Planning and Zoning Commission

May 4, 2022

TO: Planning and Zoning Commission
FROM: Molly Mannel, Assistant Planner
DATE: May 4, 2022
RE: Rocket Carwash – Site Plan

TO: Planning and Zoning Commission
FROM: Molly Mannel, Assistant Planner
DATE: May 4, 2022
RE: Herndon Property – Rezoning

L1.00

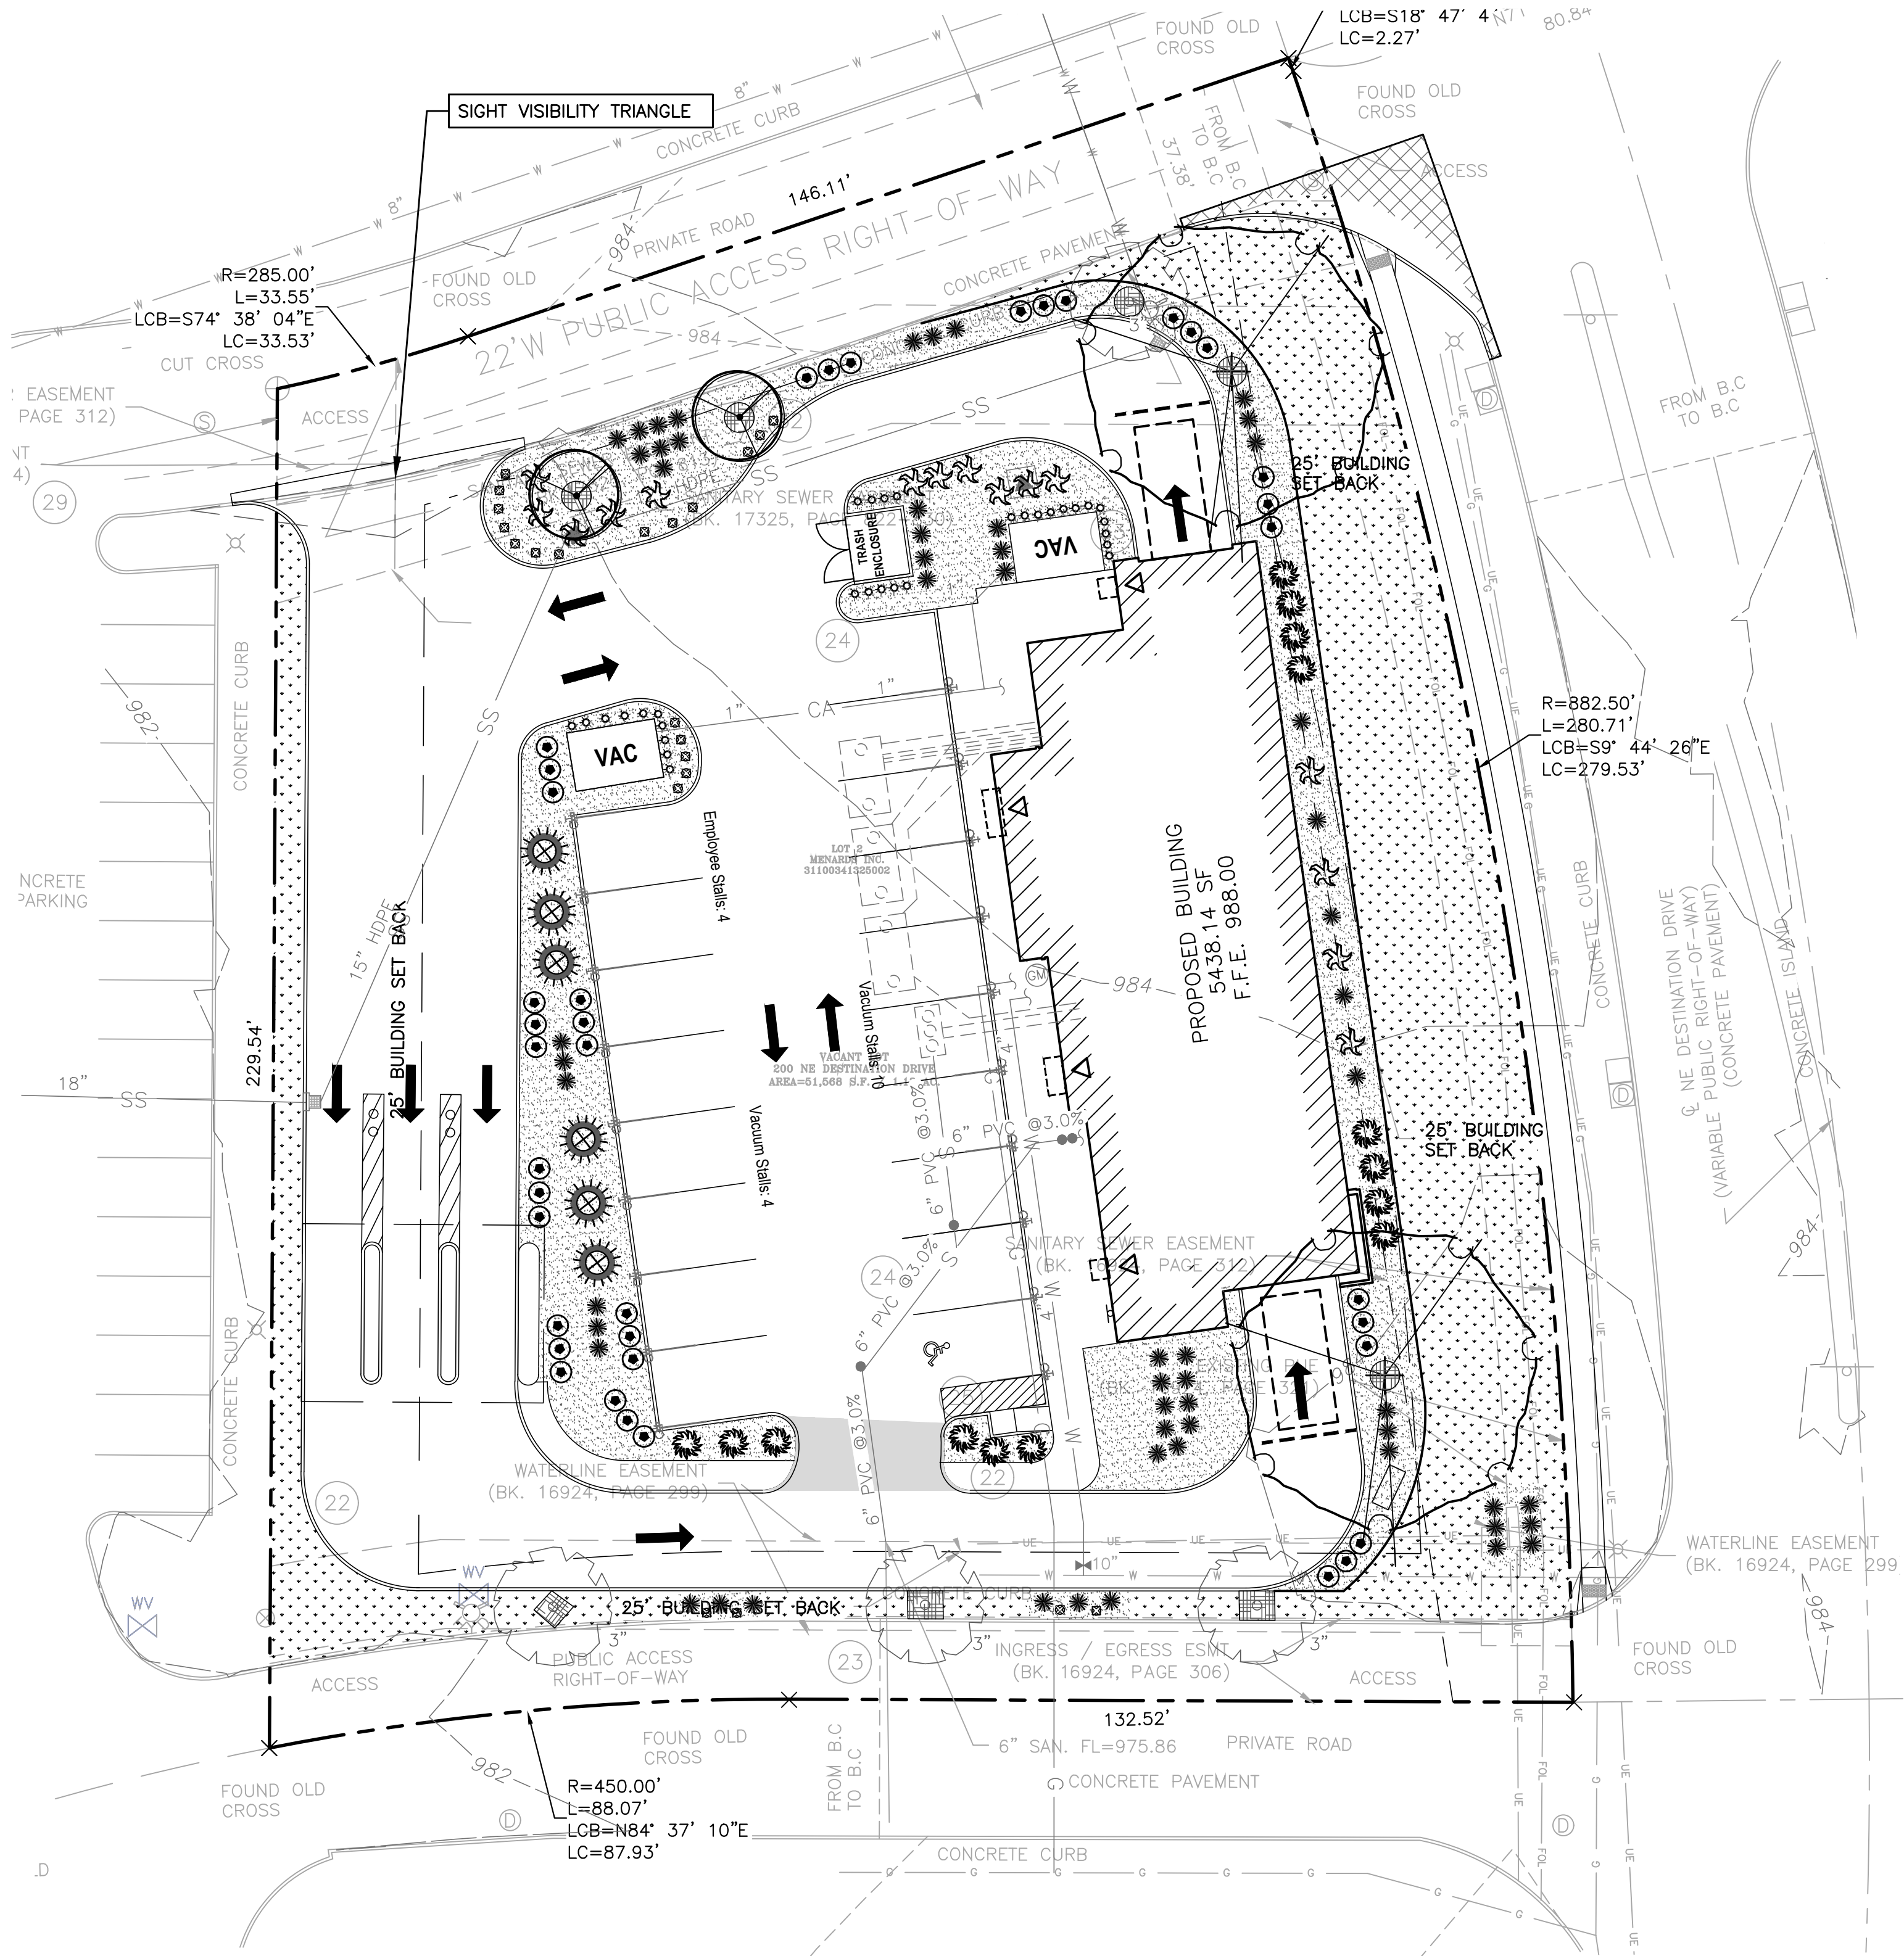
- ~~1. Is the shrub bed ground cover rock?~~
2. Label transformer location. Transformer to be screened from NE Destination Dr.
- ~~3. On the south side of the site, please shift trees at least 5' away from the hydrant and sanitary service.~~
4. Please provide required ROW tree and shrub plantings and provide the calculations for along NE Destination Dr. See 12-11-1 16.3 The two pavement areas at the tunnel entrance and exit can be used to calculate the tree requirements. Please place planting

close the pavement to keep plantings outside of the sanitary easement. Please move the two shademaster honeylocust trees within the sanitary sewer easement more to the left – closer to the pavement.

5. Please provide required open space planting calculations. See 12-11-1 16.9. Please include the open space planting calculations. Please also list the minimum 15% open space and proposed 29.4% open space on this page as well.

① ELECTRICAL SITE PLAN REVIEW
1/16" = 1'-0"

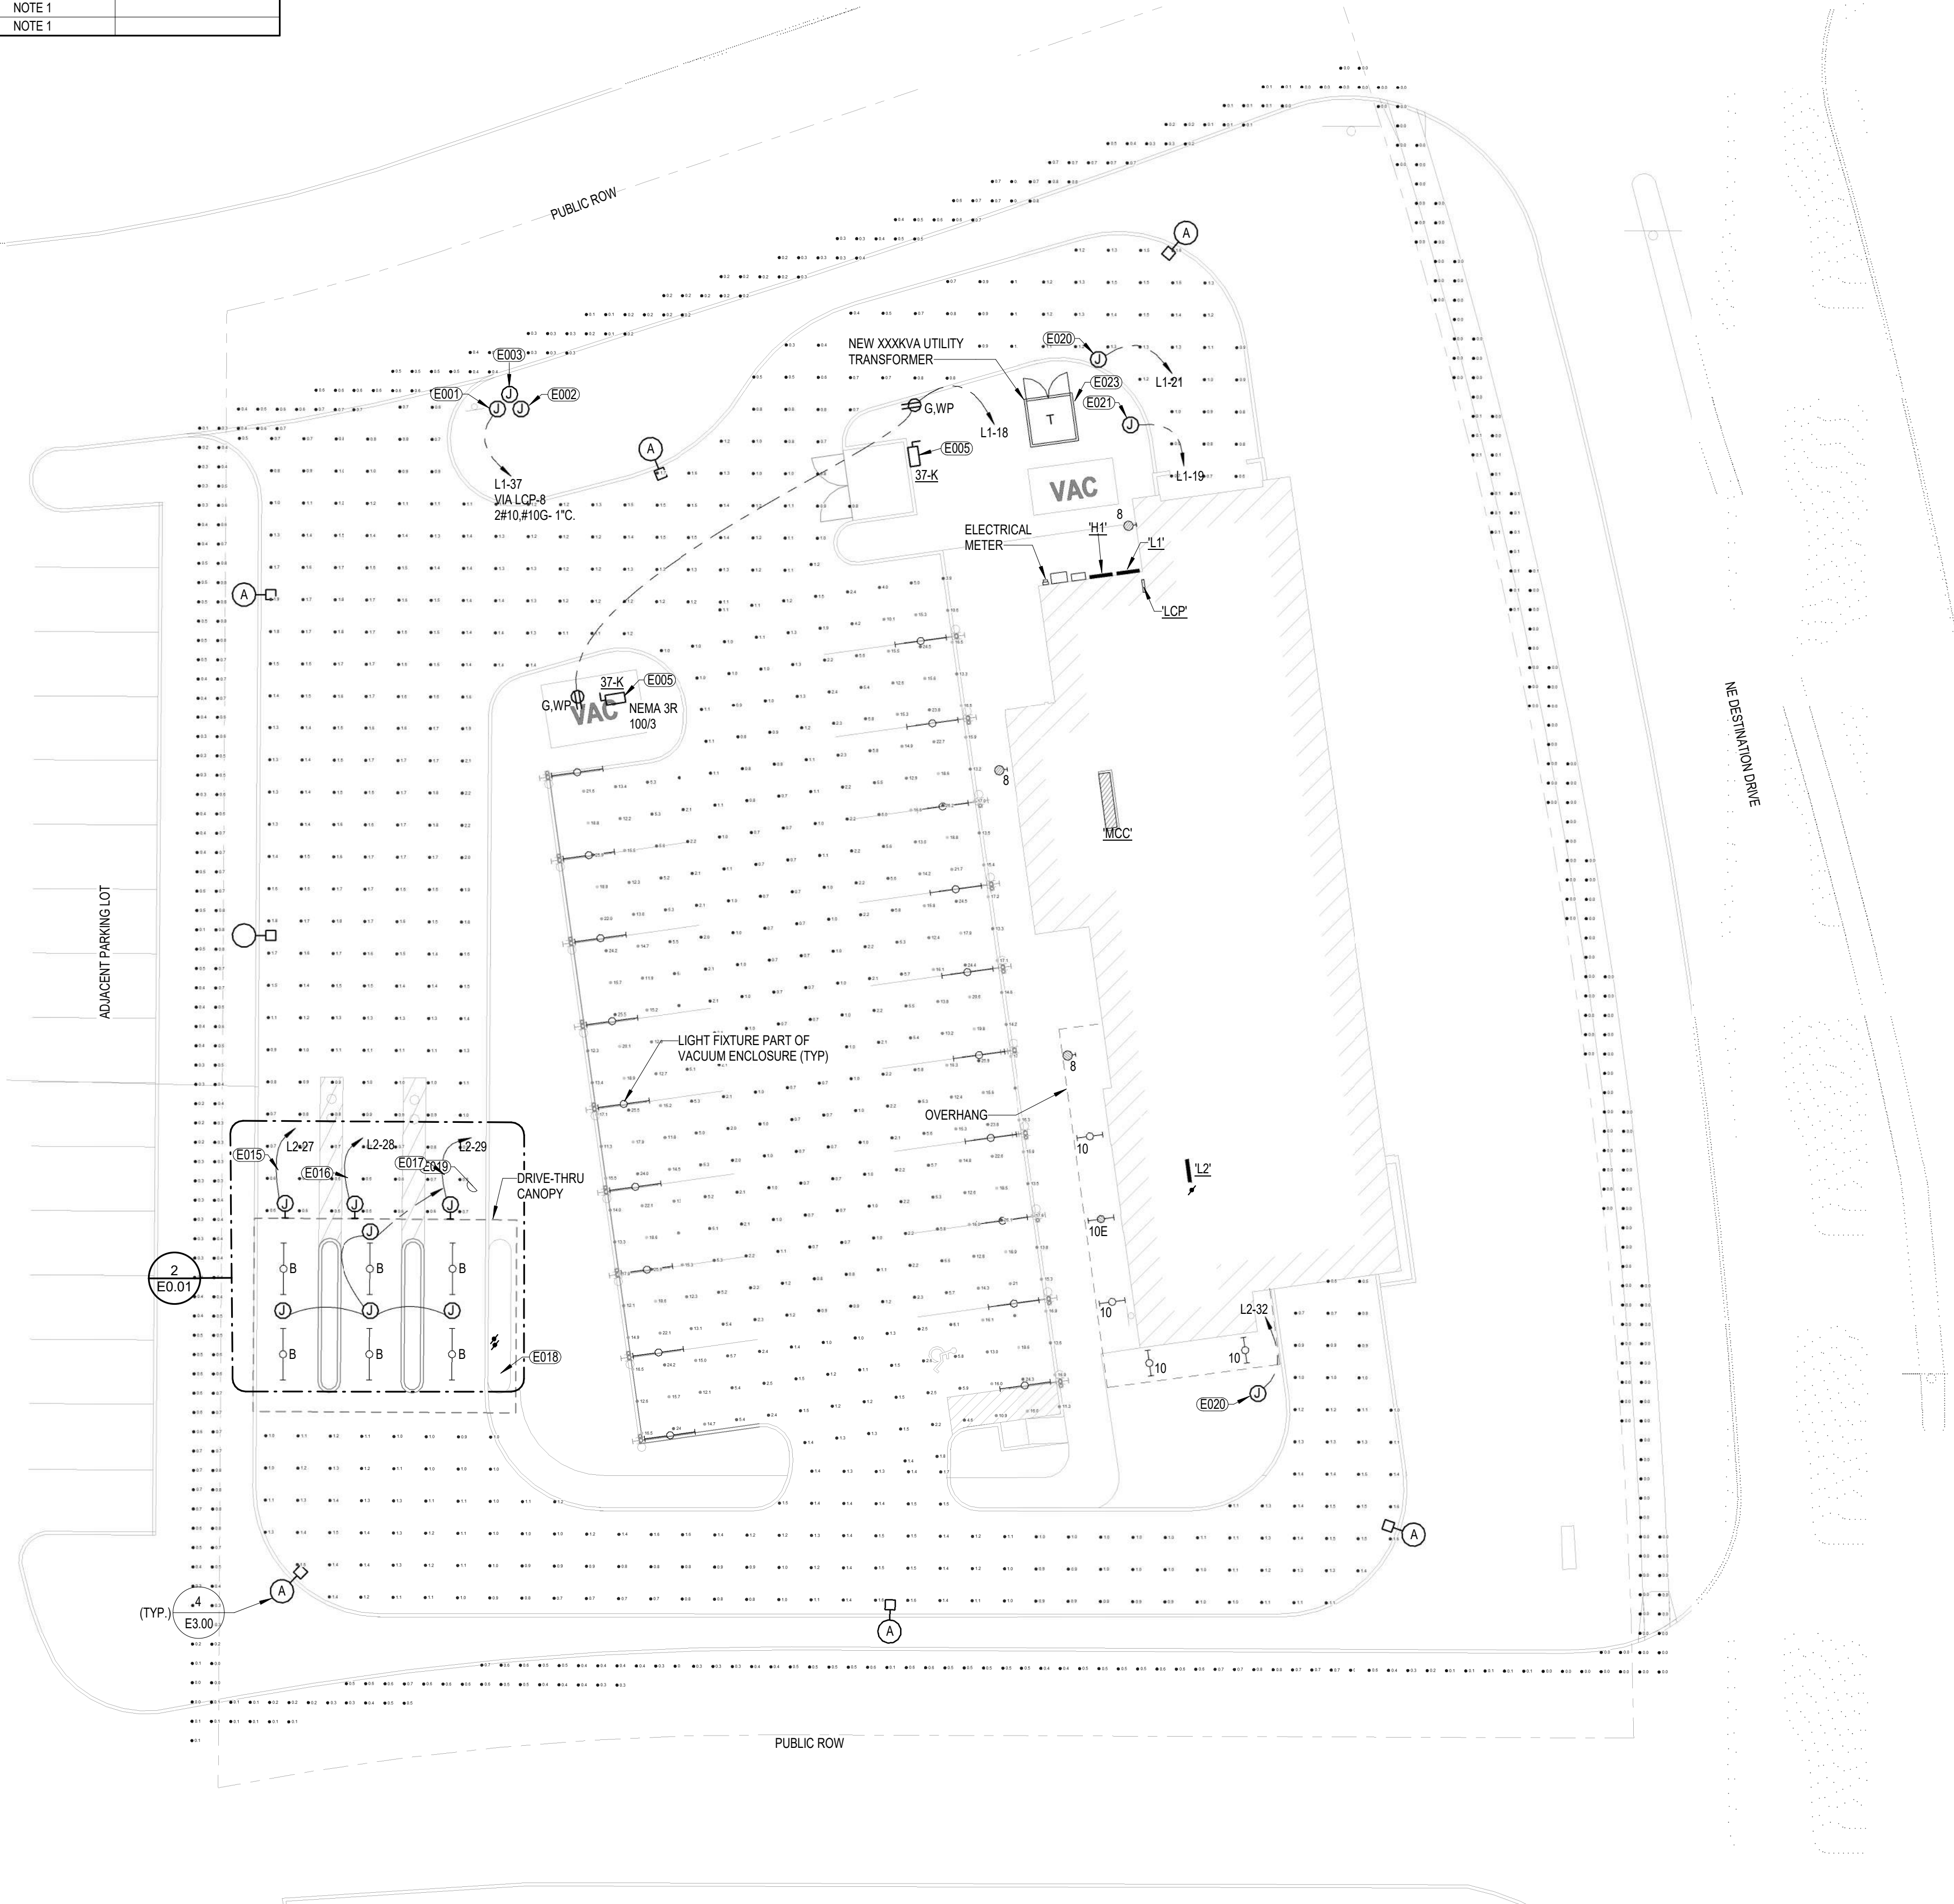
1. ~~Please label foot candle measurements across the site.~~
2. ~~Are the 10 and 10E lights under the canopy?~~
3. ~~Is lighting proposed within the tower? Please provide details.~~
4. Are any colored or changing lights proposed? Please provide all lighting details to be presented to P&Z/Council. Anything not presented/changed may need to return to P&Z/Council for approval.

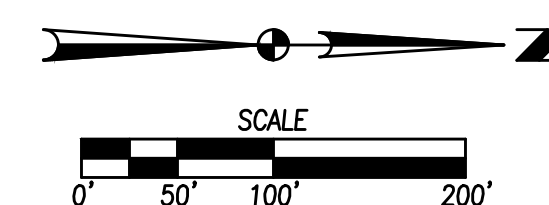
1. — Connect the parking lots of the North buildings to the South (see screenshot and outlined location in red).
2. Provide landscaping screening to hide loading dock areas from the ROW. **Please provide landscaping around the loading docks, north of Lot 3 detention.**
3. — ~~Label 5' sidewalk along north side of SE 37th St and south side of SE 28th St.~~
4. Label 8' trail along north side of SE 28th St.
5. ~~Label ROW to be dedicated to the City.~~
6. ~~Provide general utility layout for the site showing how each lot can be served.~~
